Steven Velardo
164 East Middle Patent Road
Bedford, NY 10506

RE: 164 East Middle Patent Road
Bedford, NY 10506
Section 95.02 Block 2 Lot 22

Thank you for the opportunity to present my revised submission based on the comments from the previous Planning Board meeting of November 9, 2020.

Staff Comments Planning department memo dated 11/3/2020

LS-1
 Scale: 1" = 20'-0" Issue Date: **January 25, 2021**

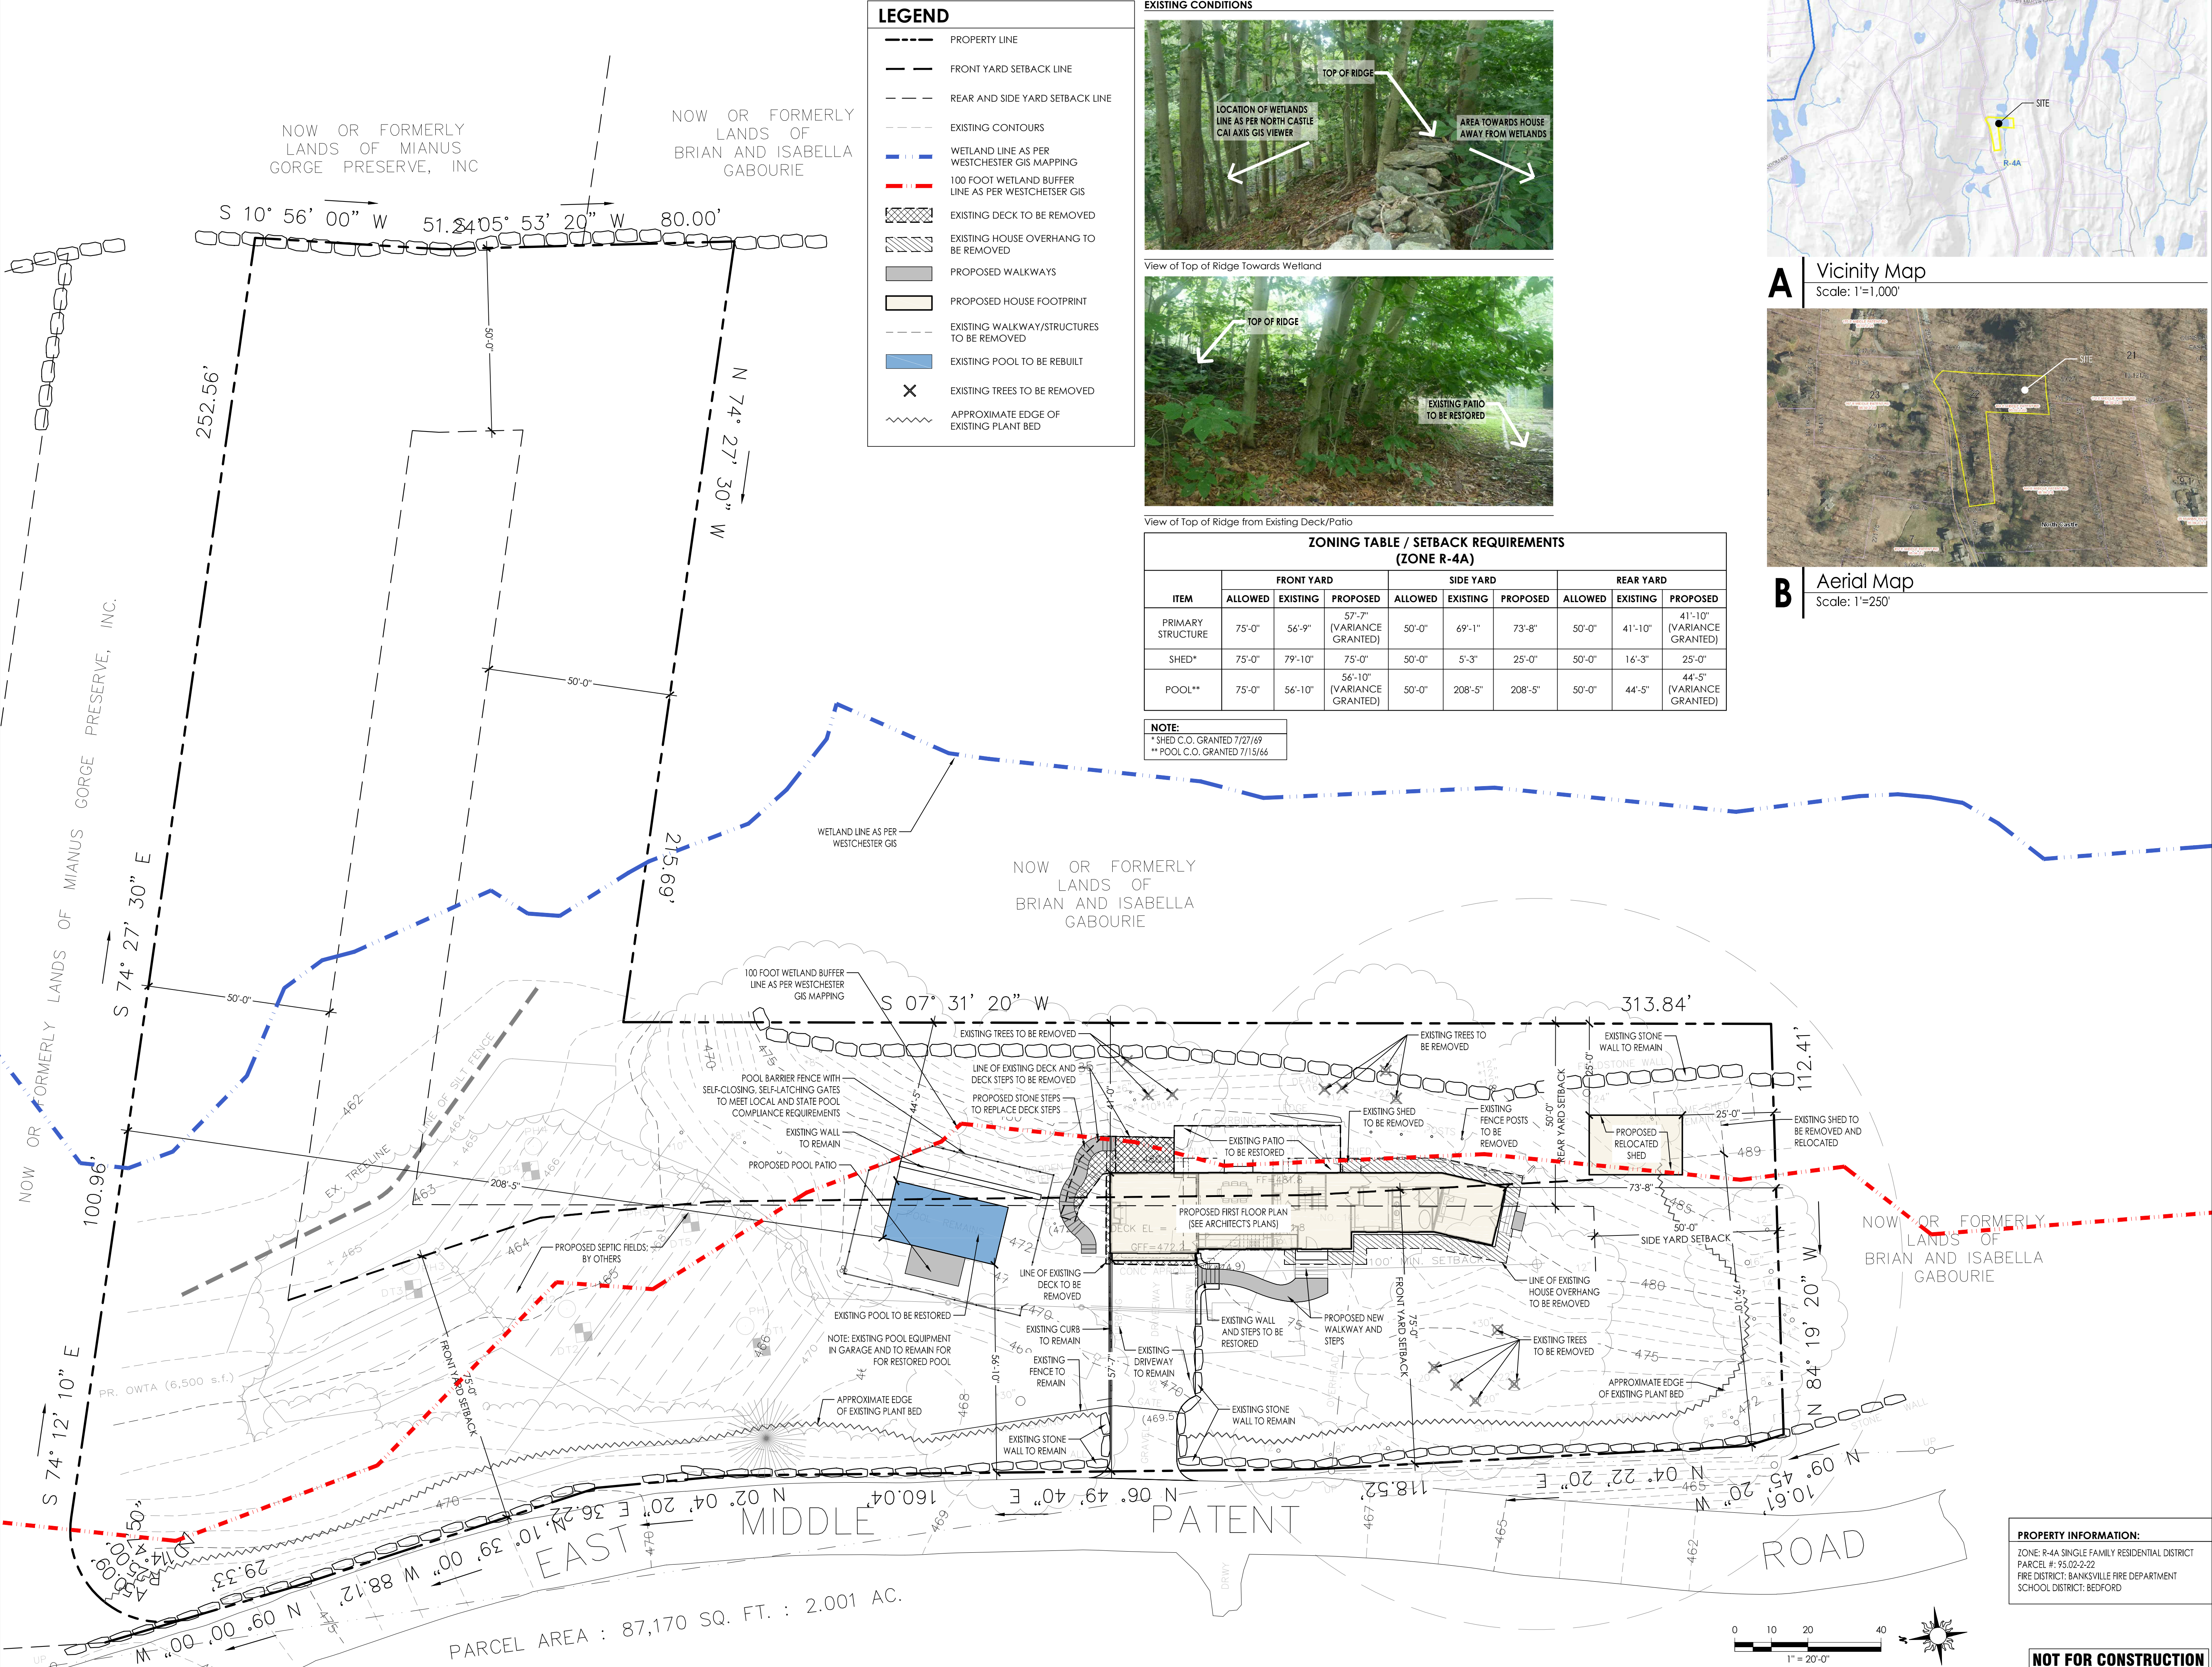
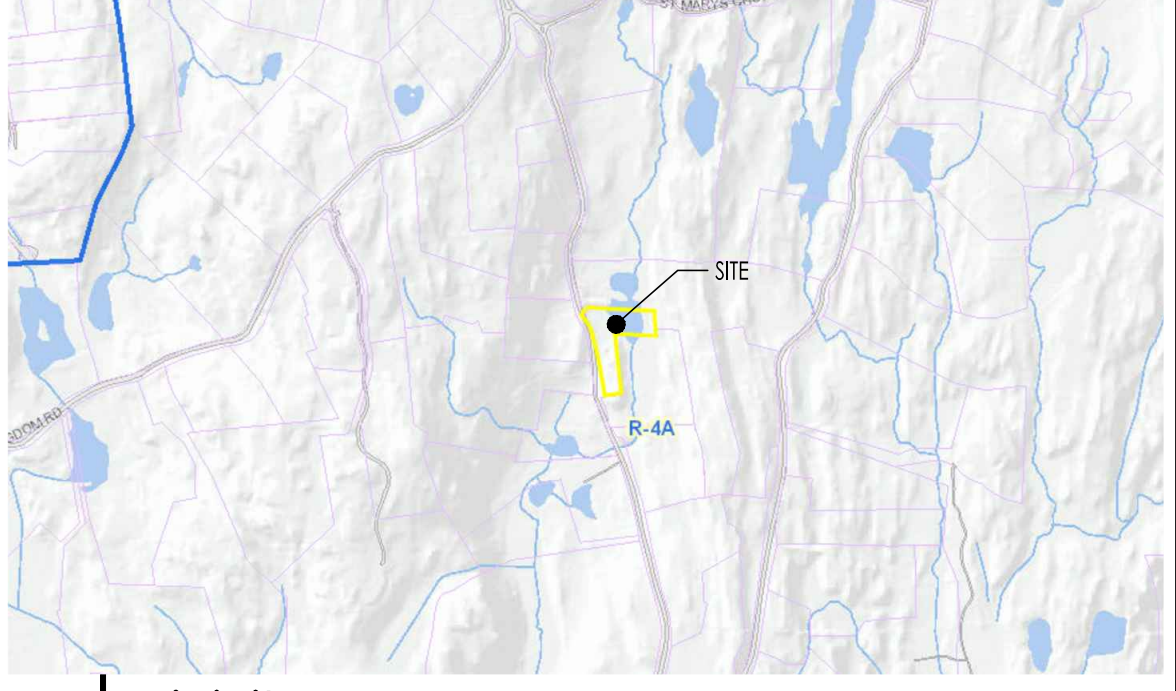
Proposed revised location for replacement shed (same Size) that meets the zoning requirements for accessory structures for Zone R-4A

(3) The existing house does not meet the minimum required front yard and rear yard setbacks Would proposed action require a variance ?

(4) Site Plan depicts tree removal and reconstruction of patio within wetlands buffer

1. Establish Wetlands Boundary / Buffer

5. Proposed restoration of the pool

6. Tree removal is appropriate for the development and restoration is consistent with Chapter 308

1. In the alternative, the applicant has requested using the Westchester County GIS mapping to establish the wetland boundary. The Site Plan shall be revised to include aerial imagery and soil data from the Westchester County GIS site to demonstrate consistency with the submitted plan.

2.. It appears that the applicant will need to update the wetland buffer accordingly. We note that the wetland buffer line has been shown on the October Planning Board submission.

As proposed on Revised Site Plan LS-1 Dated 1/25/2021

As proposed on Revised Site Plan LS-1 Dated 1/25/2021

As proposed on Revised Site Plan LS-1 Dated 1/25/2021,

As proposed on Revised Plan Site Plan LS-1, Dated 1/25/2021 depicts a revised buffer line based on WC GIS

As proposed on Revised Site PlanLS-1 Dated 1/25/2021,

Restored/replaced same size or smaller

Proposed trees to be removed are not safe, on ledge, hang over the house and are too close to the dwelling.

Full tree line remains beyond proposed trees to be removed at the rear stone wall and new flowering trees proposed for the front lawn.

As proposed on Revised Site PlanLS-1 Dated 1/25/2021,

As proposed on revised Site Plan LS-1, dated 1/25/2021,

As proposed on revised Site Plan LS-1, dated 1/25/2021,
